**REQUEST FOR WITHDRAWAL OF FINALITY AND AMENDMENT AFTER FINAL REJECTION
UNDER 37 C.F.R. § 1.116**

Serial No.: 10/656,821

Title: CIRCUIT FOR USE WITH SWITCHED RELUCTANCE MACHINES

Fig 7
-- Prior Art --

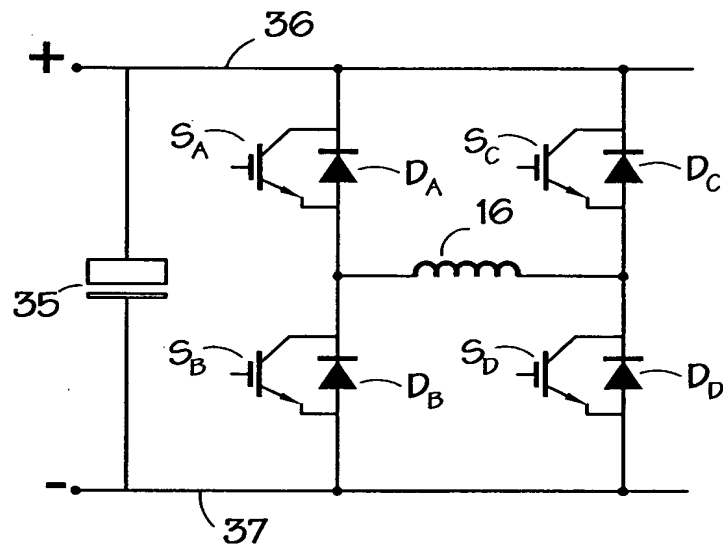
The June 3, 2005 Office Action indicated that Figure 7 should be designated by a legend such as --Prior Art--. By this Amendment, a Replacement Sheet including Figure 7 with such a legend is submitted. Applicant requests approval of this drawing change.

The attached drawing sheet adds a legend to Figure 7 and replaces the original sheet including Figures 7 and 8.
